CERTIFICATE OF APPROPRIATENESS

Applicant: Kevin Walton, Robert Sanders Homes, for Jeffery & Jessica Smith, owner

Property: 1232 Arlington Street, Lot 21, Block 190, Houston Heights Subdivision, City of Houston, Harris County, Texas. The site includes a 1½-story, 2,135 square foot residence situated on a 6,600 square foot (50' x 132') interior lot.

Proposal: New Construction – Construct a detached, one-story, two-car, alley-loading garage at the rear of the property. The garage will be 20' wide by 23' deep, have a total ridge height of 13'-9", and will be clad in cementitious lap siding.

FIRST FLOOR PLAN
PROPOSED

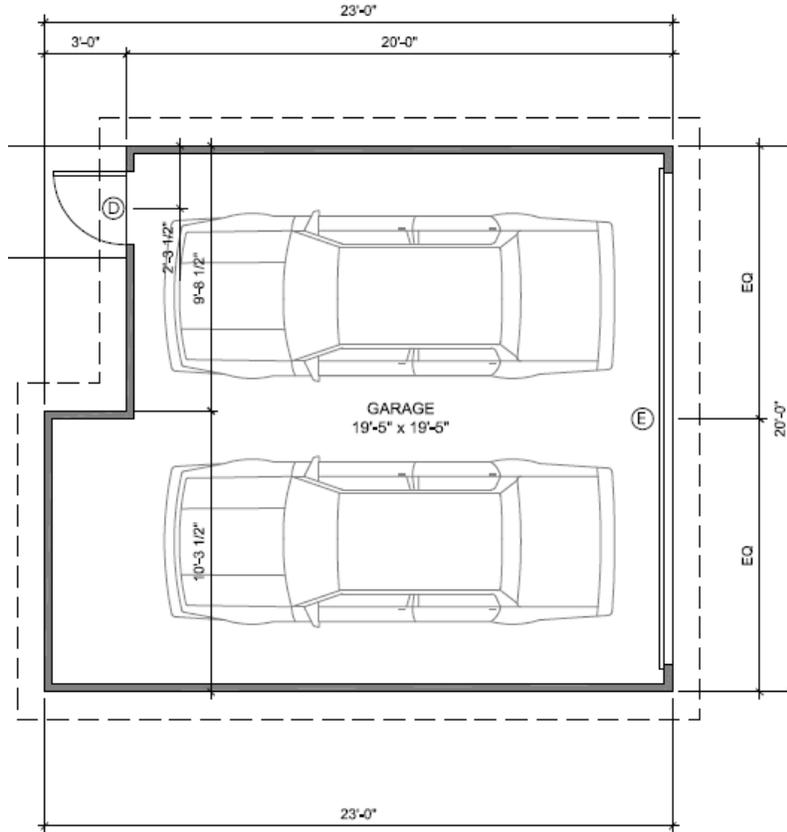
Setbacks: The proposed garage will have a north side setback of 26'-11"; a south side setback of 3'-0"; and a rear (east facing alley) setback of 5'-0". The garage is 4' too close to the alley. Code requires 24' of clearance between the garage door and opposite side of the alley. Currently, this garage has 20' of clearance. The applicant has been working with the Public Works Department to secure a reduced garage setback of 20'. See drawings for more detail.

Agenda Item #29 - 1232 Arlington (Garage) – I **support** this application. This garage is proposed to be detached and at the rear of the property as is typical in the district. Note the proposed 20-foot clearance, noted on the site plan, at the rear of the property between the garage door and the far side of the 15-foot wide alley is not sufficient for vehicular ingress/egress with the garage.
